**Official Transcript of Proceedings**  
**NUCLEAR REGULATORY COMMISSION**

Title: Advisory Committee on Reactor Safeguards  
Kairos Power Licensing Subcommittee

Date: Thursday, March 23, 2023

KAIROS POWER LICENSING SUBCOMMITTEE

# SCALE Results: Power Distribution

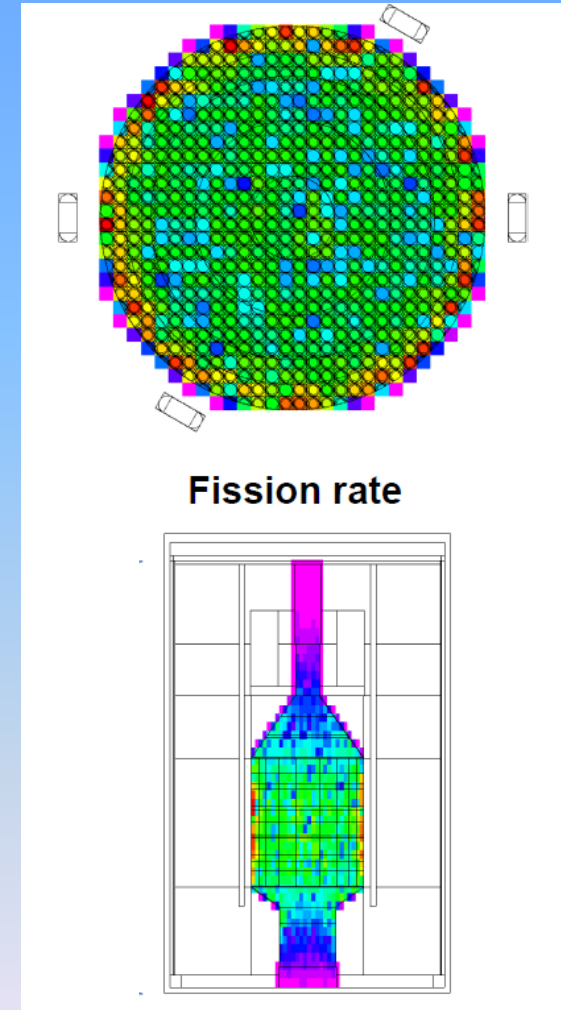
- Excellent agreement axially
- Not as good radially or at peak pebble
  - Inconsistencies in peaking definitions
  - Inconsistencies in reflector model
  - Differences in pebble treatment – averaged vs. pass/location dependent isotopics
- *Reasonable*, given uncertainties – could be resolved with additional information
